RESPONSE TO COMMENTS

Darigold Inc.
NPDES Permit ID0024953
February 19, 2019

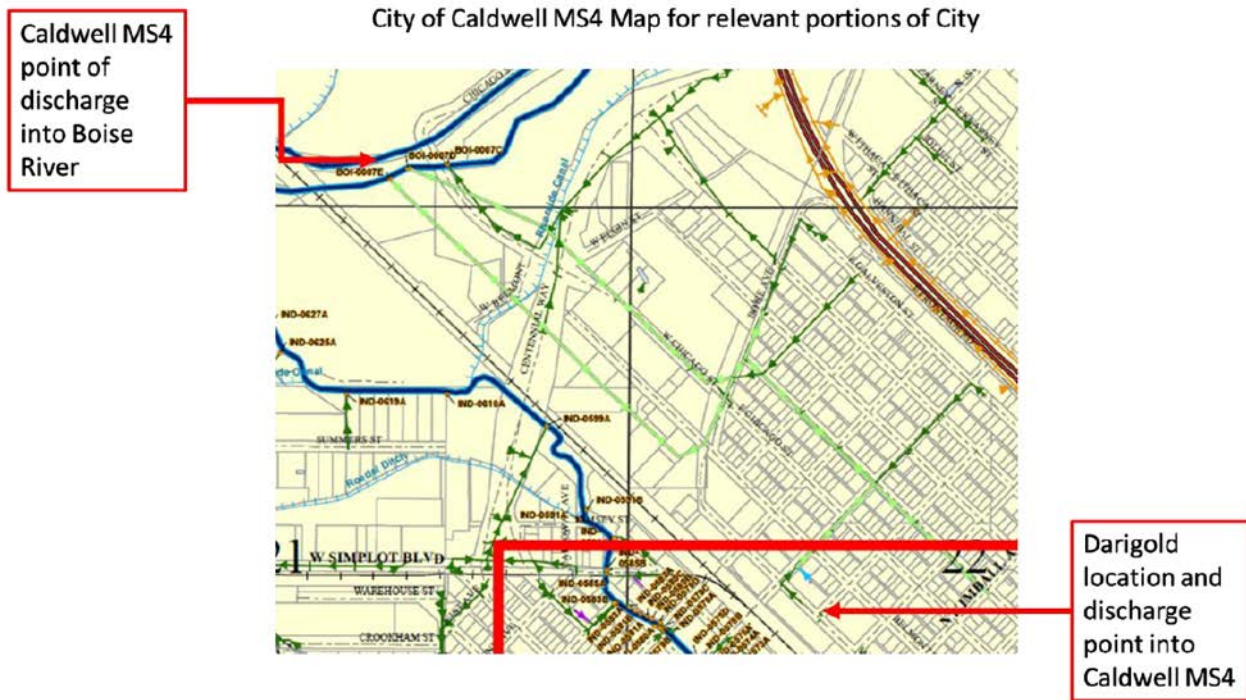
The EPA disagrees that the monitoring data indicates that the current discharge will not always be in compliance with the pH range limitation, both on the low and high end of the range and will involve a more complex control system than if the compliance challenge was on one end of the range.

In the last five years Darigold has never exceeded the lower pH limit and has only exceeded the upper pH limit once in the last five years. The table below shows recent data.

Therefore, a compliance schedule is not required for Darigold to meet the effluent limits for pH.

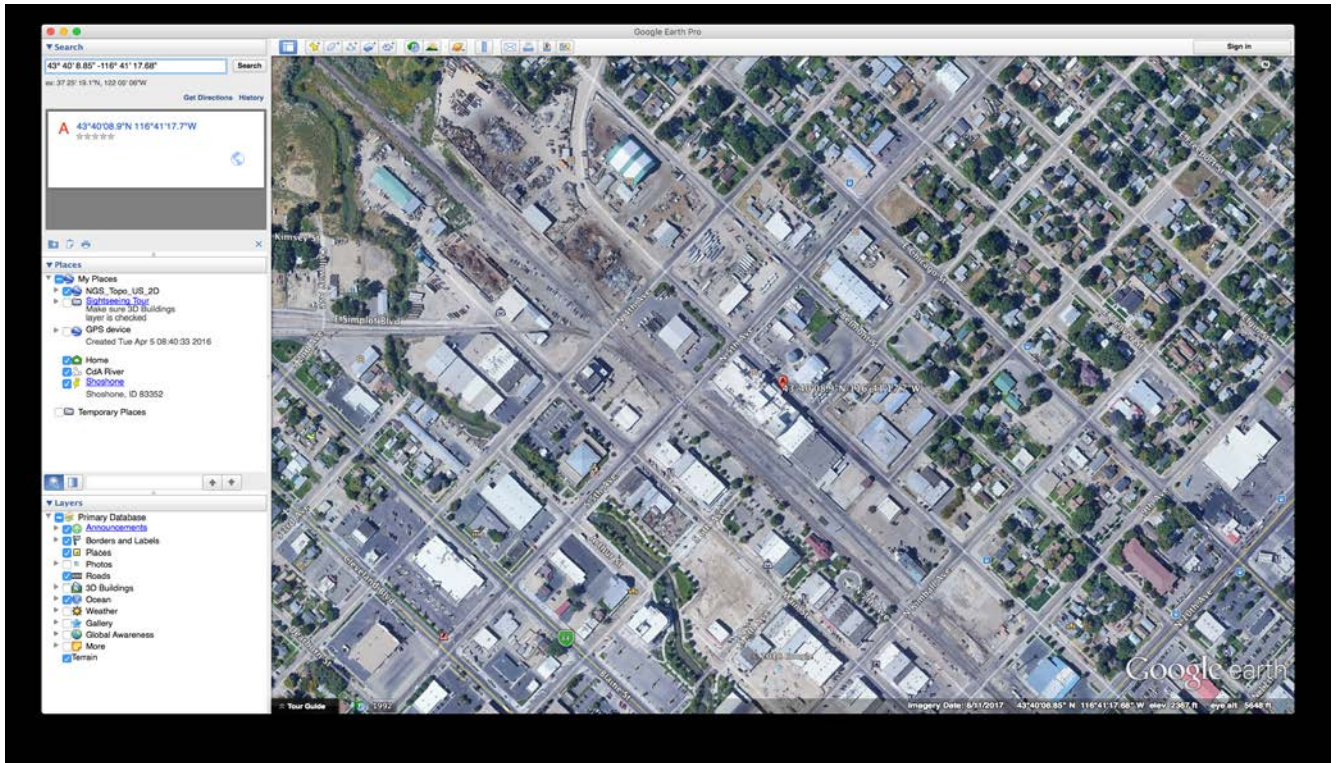
Appendix D of the Fact Sheet shows the Reasonable Potential Analysis (RPA) for ammonia. The RPA determined that ammonia discharges from this facility did not have a reasonable potential to exceed water quality standards; however, this result is contingent on a number of factors, including that ammonia concentrations in the effluent do not exceed 8,590 µg/L. We encourage the EPA to include 8,590 µg/L as an effluent limit for ammonia given that the results of the RPA are only valid if this value is not exceeded.

Further, under “Critical River Flows,” 234 cfs is listed as the 30B3/30Q10 Annual Critical Flow rather than the 30Q5 critical flow, differing from Table 4 in the Fact Sheet. We are concerned that the RPA calculations relying on this value may be inaccurate if the incorrect critical flow was used. We request that the EPA ensure the correct values are utilized for the critical low-flow values (i.e using 234 cfs as the 30Q5 flow) and that the RPA for ammonia be redone using the correct values to ensure the final results are correct and accurate.

Response: As the fact sheet states using procedures in the Technical Support Document, the reasonable potential multiplying factor (RPMF) is used to derive the maximum projected effluent concentration (Ce). Using the RPMF and the 95th percentile representing the highest reported concentration discharge concentration a reasonable potential to violate the water quality standards for ammonia is derived. If there is no reasonable potential to violate the ammonia during these worst case conditions there is no necessity to establish an effluent limitation for ammonia. The Fact Sheet concluded using these procedures there is no reasonable potential to violate the water quality standard for ammonia under these worst case conditions and therefore an effluent limitation is not required and not established.

As the fact sheet states on page 11 30Q5 can be used for the ammonia reasonable potential calculation.

The spreadsheet is mislabeled. It should say on the line for chronic ammonia critical flow 30B3/30Q10/**30Q5**. These long term averages can all be used to determine the reasonable potential to violate the chronic ammonia water quality standards.

Spread of a Plume from a Point Source in a River with Boundary Effects from the Shoreline

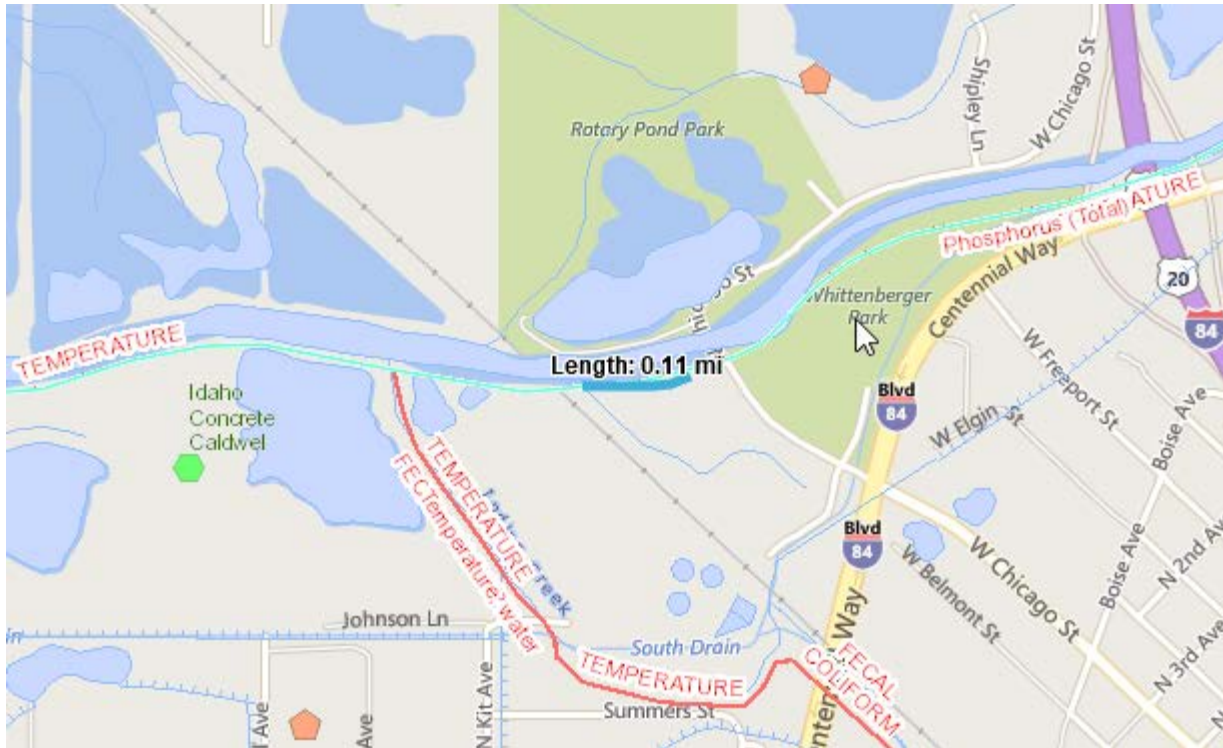
Idaho DEQ (IDEQ) is proposing a 10% mixing zone for ammonia as part of this permit and 401 Certification. We have concerns over the appropriateness of mixing zones for this facility given the outfall locations proximity to the City of Caldwell’s WWTP. There is likely overlap between these two discharges; thus, the typical dilution assumptions accompanying mixing zone decisions may not be applicable (i.e. the efficacy of dilution in waters being simultaneously polluted by a different source). We request that the EPA and or IDEQ explain their consideration of this scenario and discuss any analysis that was performed to assess the appropriateness of a mixing zone for this discharge.

Response: The EPA used Riverplume6 dispersion modeling and measurements in the vicinity of the outfall to the Boise River to determine the impacts to the City of Caldwell 580 feet downstream. River depth came from the 1999 USGS publication *Stream Channel Cross Sections for a Reach of the Boise River in Ada County, Idaho*. Complete mixing occurs approximately 164 feet downstream of the Darigold outfall well before impacting the mixing zone for the City of Caldwell 580 feet downstream. Therefore the mixing zone analysis is appropriate. The spreadsheet is shown below.
